Genser-Forman Inc. TRIUMPH DISTRIBUTORS

TO: ALL DEALERS
DEPT: SERVICE & PARTS

BULLETIN: T-62-9
DATE: AApril 19, 1962
SUBJ: TRIUMPH HERALD
HORNS

DESCRIPTION.	MODEL.	ISSUE: -1
ENGINE RESTRICTOR BRACKET -- TO PREVENT EXCESSIVE ENGINE MOVEMENT & SO MAINTAIN CLEARANCES TO BOWNET CLEARANCES.	TRIUMPH TR 4.

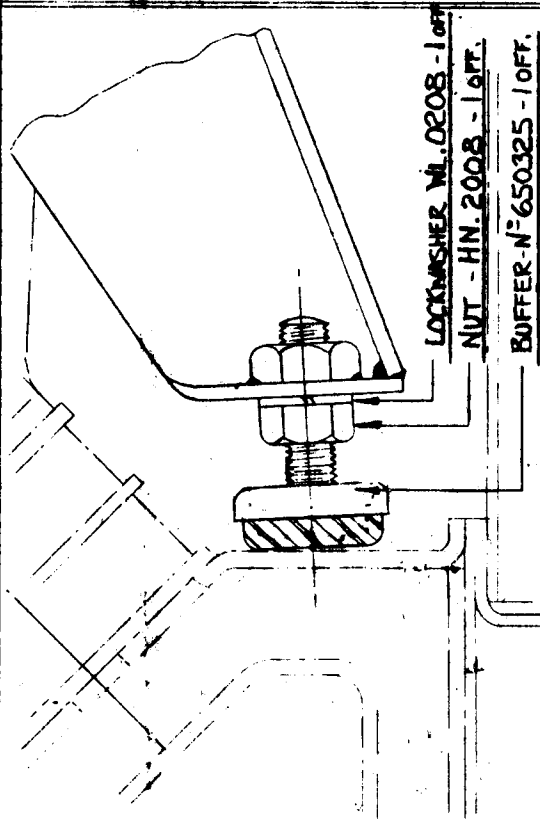
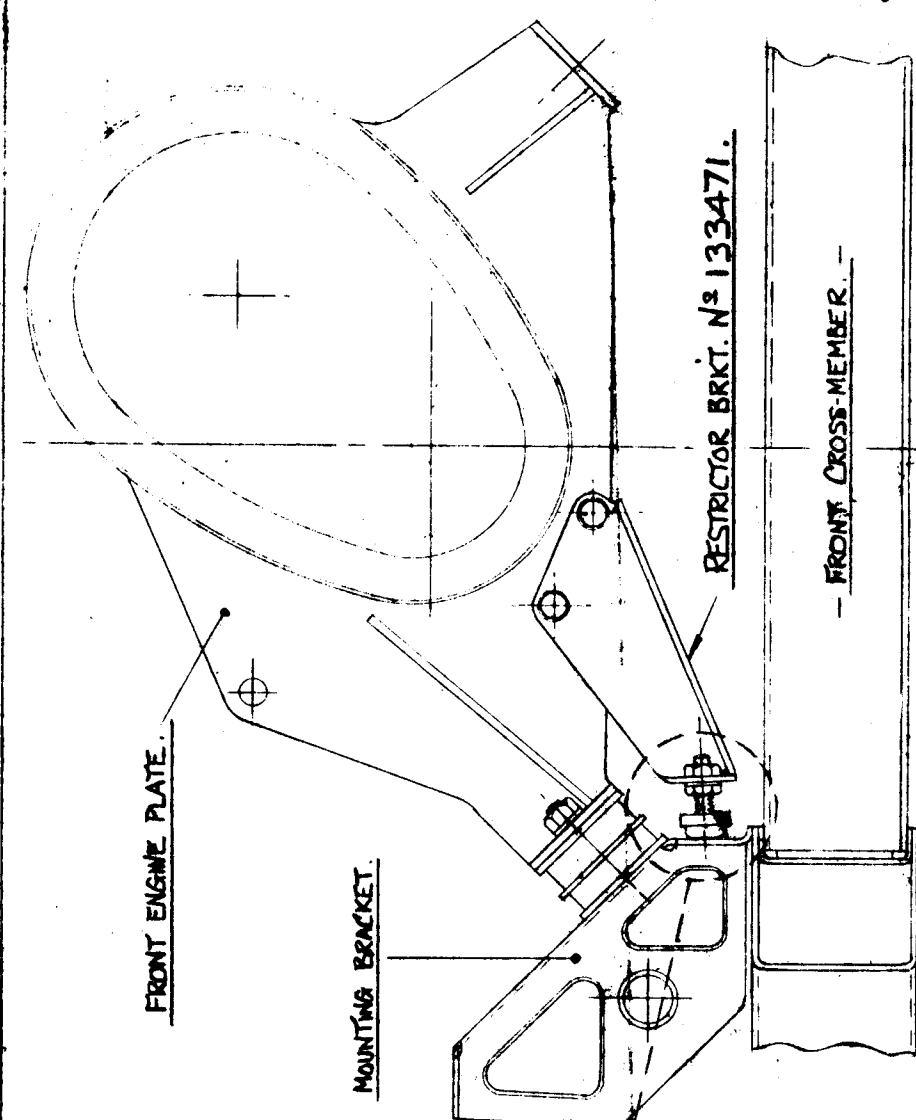
Attached hereto is a drawing of Part No. 133471, Engine Restrictor Bracket - TR4, designed to prevent damage to the power bulge on the hood by carburetors contacting this point under the influence of engine reaction movement.

This modification has been incorporated from commission No. 3055 and will continue until such time as increased clearance at this point is introduced. The bracket fits to existing bolts and minimum fitting time is involved.

- 1/ SCREW BUFFER INTO RESTRICTOR BRACKET LEAVING LOCKNUT LOOSE.
- 2/ BOLT BRACKET TO ENGINE PLATE IN POSITION SHOWN USING EXISTING BOLTS.
- 3/ SET FT. FACE OF RUBBER BUFFER JUST TOUCHING FACE OF ENG. MTS. BRKT. & TIGHTEN LOCK NUT AS SHOWN.

BOSS TAPPING DETAILS.

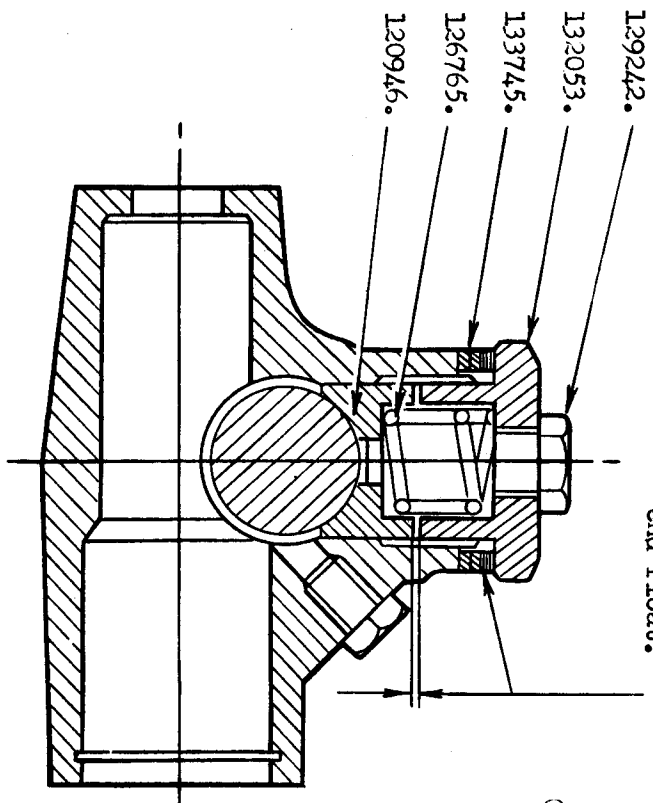
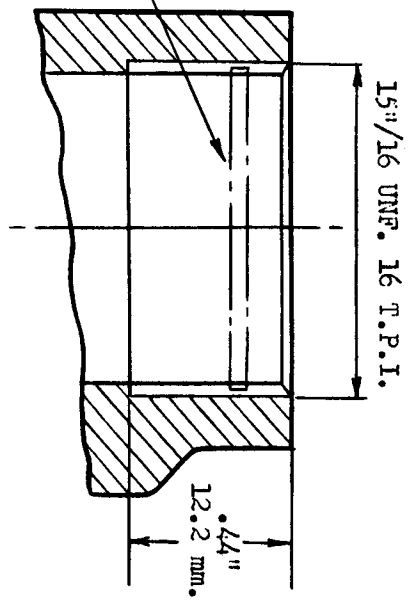
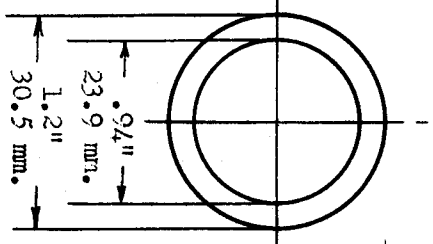
Some steering units incorporate a circlip and spring plate to retain the plunger in the rack and pinion assembly. Should circlip failure occur, modify the unit to the current screwed cap and spring method of retaining the plunger, as illustrated overleaf and described below:

1. Remove and dismantle the steering unit as described in the Service Manual (Group 4)
2. Tap the plunger boss housing to a depth of $.44$ " (12.2mm), using a $15/16$ " UNF, 16 TPI tap.
3. Thoroughly clean the housing and pack with the correct grade of grease when refitting the rack and pinion.
4. Fit new plunger 120945; spring 126765; and screwed cap 132053, placing two packing washers 133745, and sufficient shims 120949 and 120959 between the cap and housing to obtain correct end float.

Use shims 120949 and 120959 as required to give 0.004" - 0.008" (0.1- 0.2 mm.) plunger end float.

This method of securing plunger may be incorporated on Part Number 205628 and 304737 when serviced for complaint of circlip not holding in position.

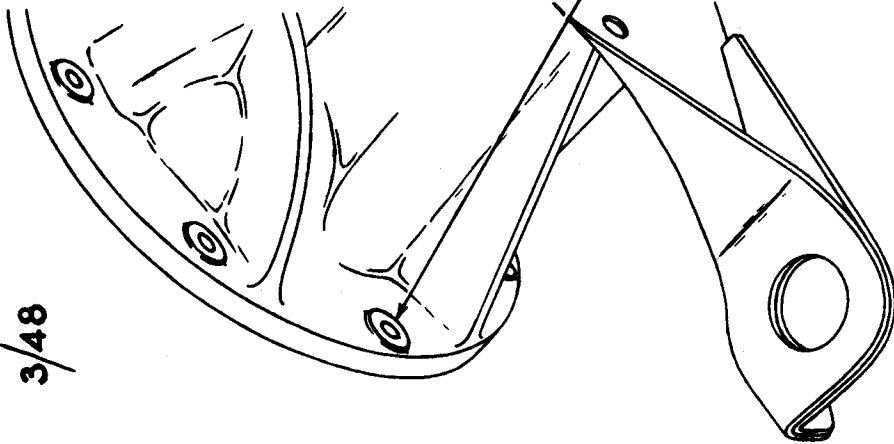
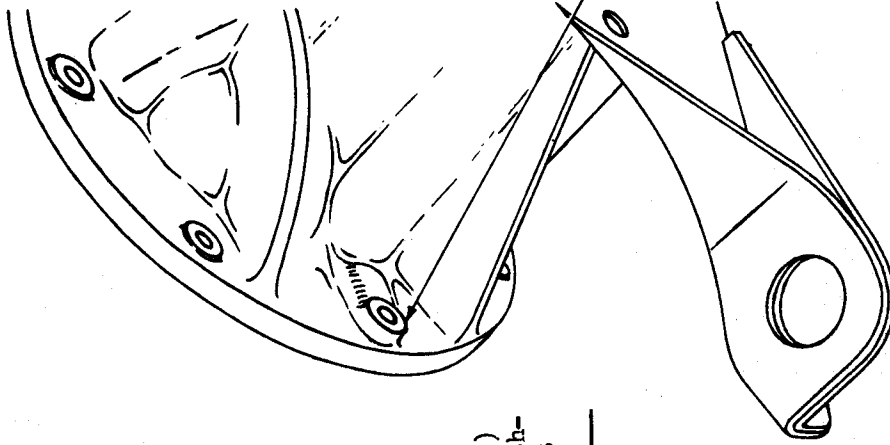
The hypoid housing was, until recently, attached to its casing by six setscrews (Part No. HU 0808) and two shorter setscrews (Part No. 124717), the latter being fitted in the holes adjacent to the inner shaft bearings. Should the longer bolt be fitted in either of these two holes, damage to the inner shaft bearing would occur.

To prevent such damage all current hypoid housings have two raised bosses at these points, allowing the use of eight identical bolts.

Fit two short setscrews
 $\frac{3}{4}$ " long Part No. (124717)
to attachment flange with-
out bosses at this point
and the opposite side.

Fit two longer setscrews
1" long Part No. (HU.0908)
to attachment flange having
bosses at this point and the
opposite side.

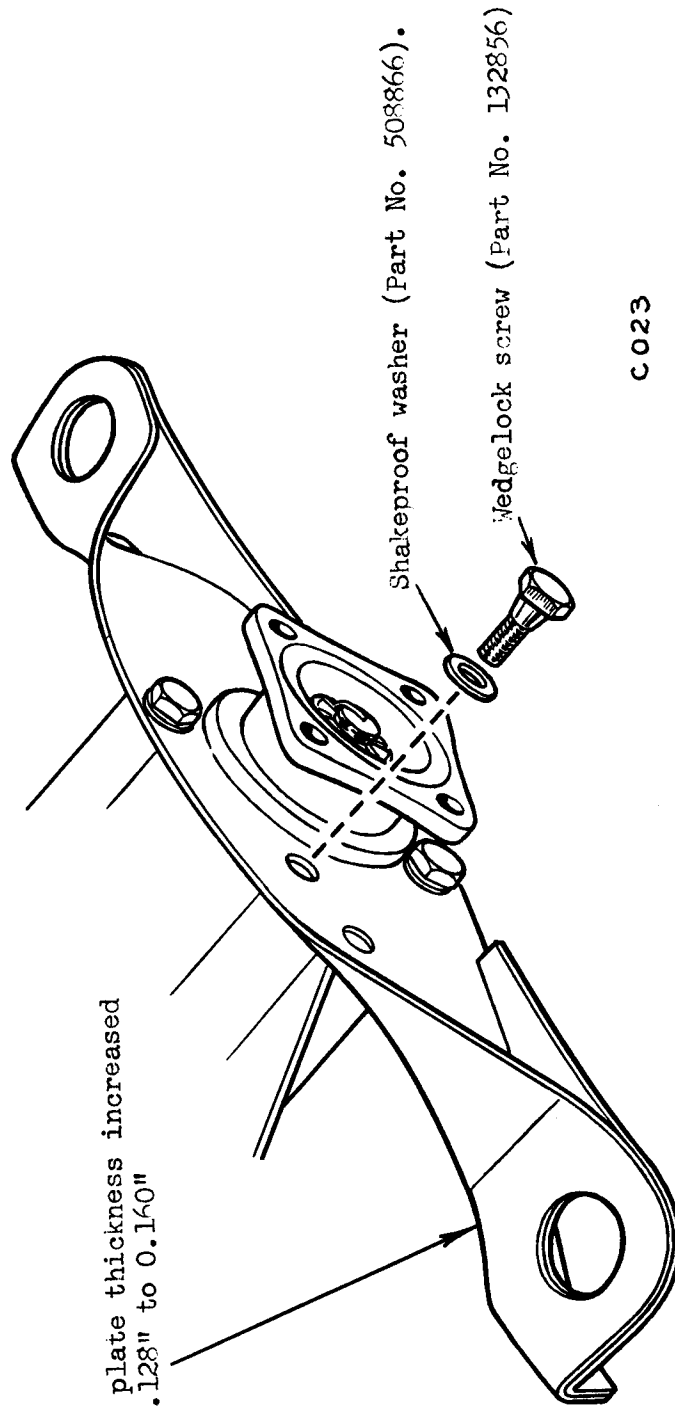
At commission numbers G 65719 SP and GA 14733 the thickness of the bearer plate was increased from 0.128" (3.23mm) to 0.160" (4.060mm). At the same time the Wedgelock setscrews were modified by lengthening the taper to accommodate the extra plate and nose piece.

Therefore, when rectifying a complaint of loosened setscrews, fit the modified type (Part No. 132856), tightened to a torque of 34-36 lb ft.

Bearer plate thickness increased
from 0.128" to 0.160"

SUBJECT: Jumping Out Of
Reverse Herald Models

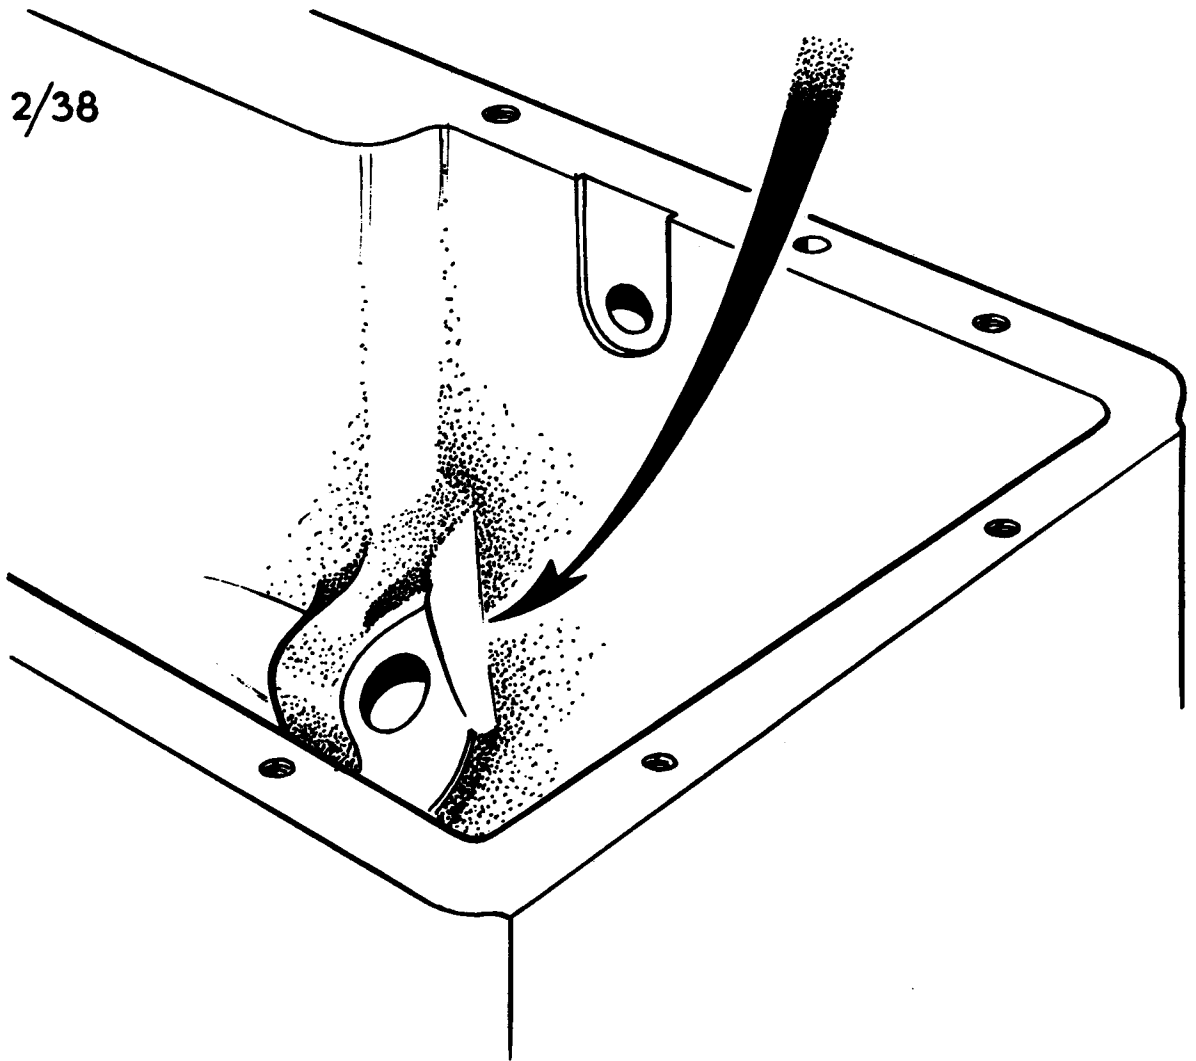
If complaints are received of jumping out of reverse gear on Herald Models, the following procedure should be adopted:

- (a) Remove and dismantle the gearbox.
- (b) Examine the boss of the gearbox casing for casting flash, the presence of which will prevent full engagement of the reverse pinion. Remove any flash with cold chisel.

- (c) Check the reverse operating lever, Part No. 106254, for fouling on the side of the gearbox casing, which will also prevent full engagement of the pinion. If necessary, fettle the casing with a chisel.

- (d) Fit a new operating lever fulcrum pin, Part No. 106448, as the original will, in all probability, be bent through the action of the gear jumping out.

- (e) Renew the reverse gear idler assembly, 130060(1200 model), 113077(948 c.c. model), together with the first gear and hub assembly, 509652.
- (f) Check the end float of the main gear assembly, which should be .004" to .010". If necessary, fit a new thrust washer, Part No. 131843.

- (g) Check the movement of the reverse selector fork in the gearbox lid. Some clearance is essential between the end of the fork and the lid, to ensure full engagement of the selector plunger in the selector shaft, in the reverse position. The absence of any clearance will prevent engagement of the plunger to the full depth of the groove in the shaft.

SUBJECT: Door Ventilator
Rubbers Herald Models

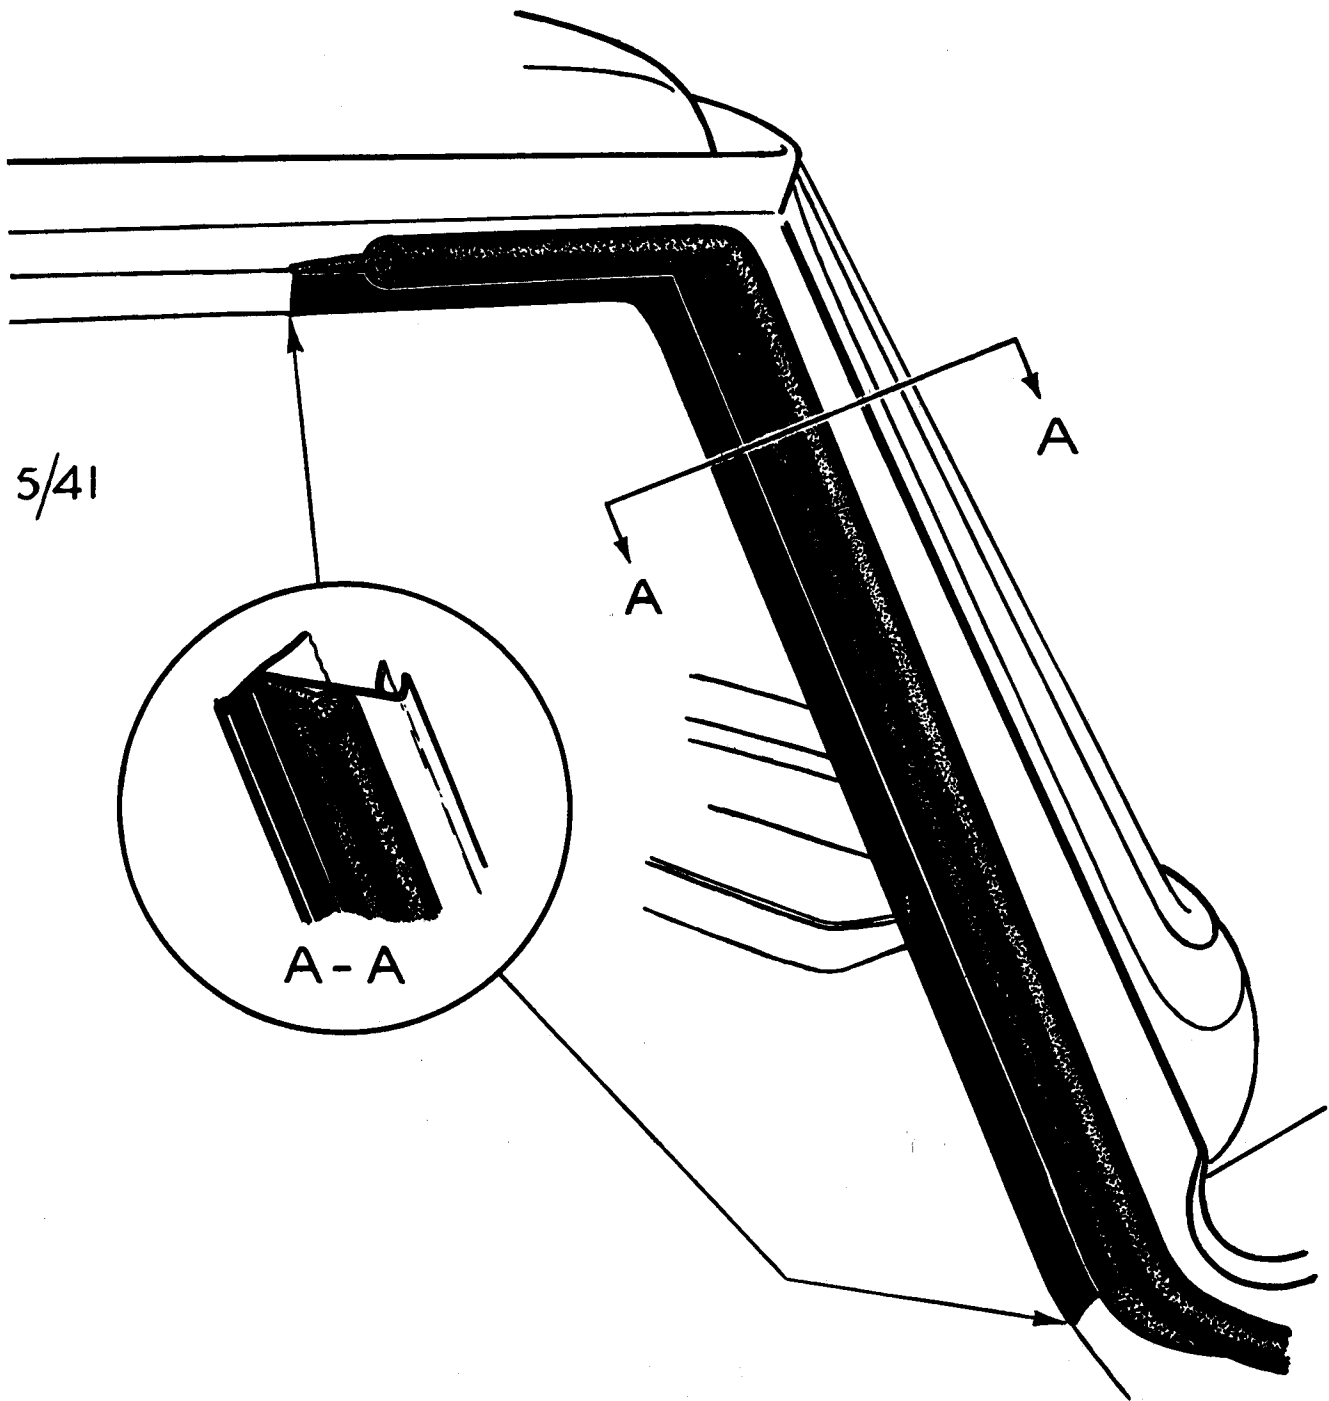
An improved type of front ventilator auxiliary sealing rubber has recently been introduced. The new rubber, which is of a "P" section, enables closer door and ventilator clearances to be obtained.

The modified rubber, Part No. 612260, can be fitted to all models and should be used to replace the earlier condition, when the occasion arises.

1. Remove the original sponge rubber seal.
2. Thoroughly clean old adhesive from the faces of "A" post.
3. Detach the door inner seal from the body aperture, from approximately half way along the aperture, to below the waist line.
4. Place the new rubber along the inside of the door aperture with the flat edge of the "piping" adjacent to the aperture flange. Attach a length of Scotch Boy tape to the flat section of the rubber and secure to the flange, as illustrated.
5. Stick the bottom portion of the rubber to the inside of the body post below the waist line--see illustration.
6. Replace door inner seal, which will lap over the Scotch Boy tape, and finally, secure the rubber in position.
7. Reset door and ventilator clearances, as necessary.

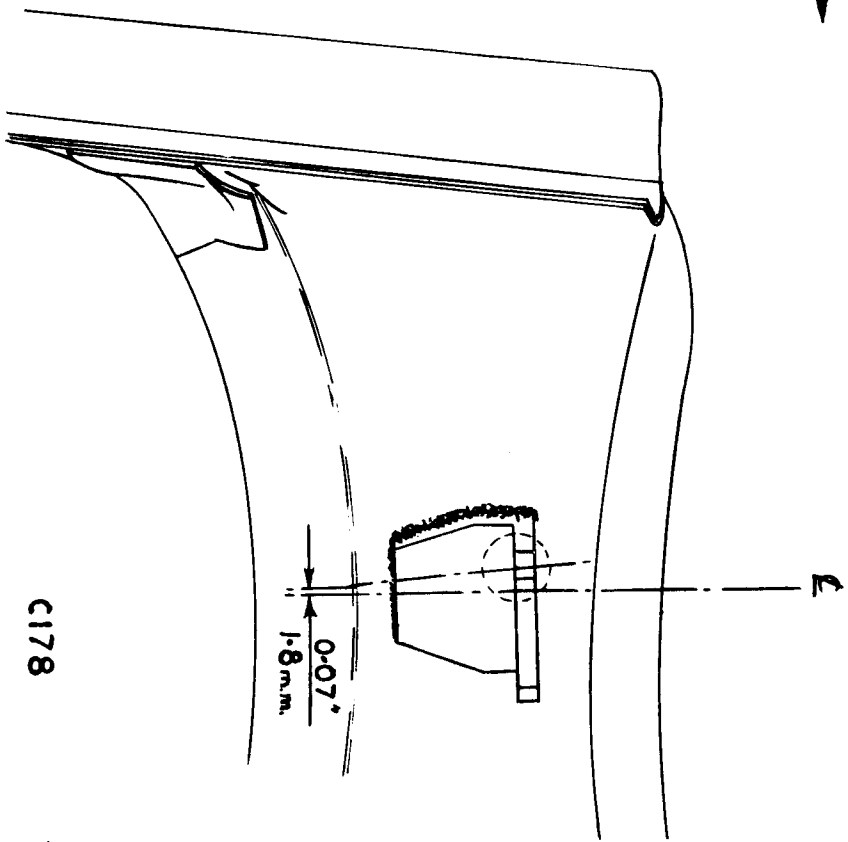
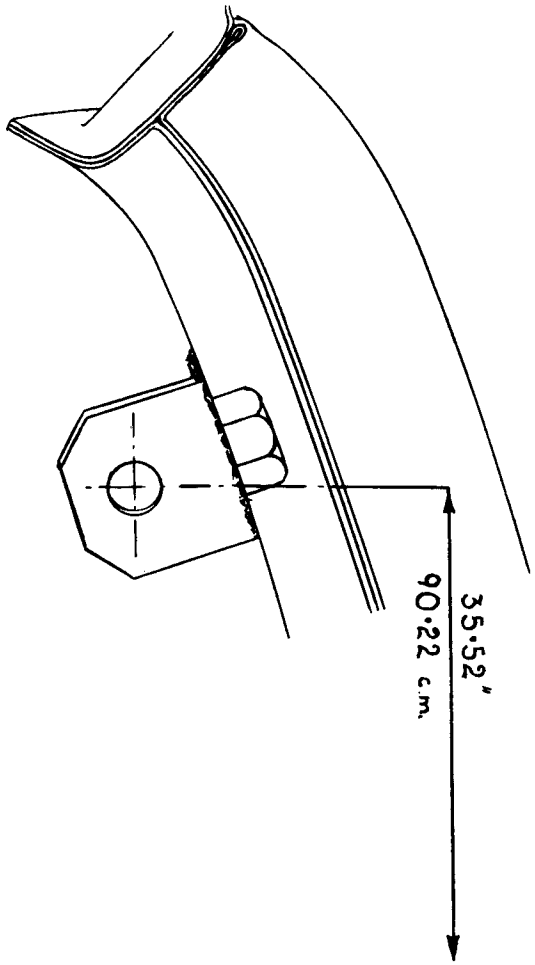
Minor modifications to the existing windscreen header panel are necessary when fitting a later type roof to early models.

File all welding burrs from around the fixing holes in the windscreen header panel.

Position the bracket as illustrated and gas weld it securely to the header panel.

The roof panel is secured to the brackets (2) using clamp bolts, washers, and tapped plate (3, 4, and 5).
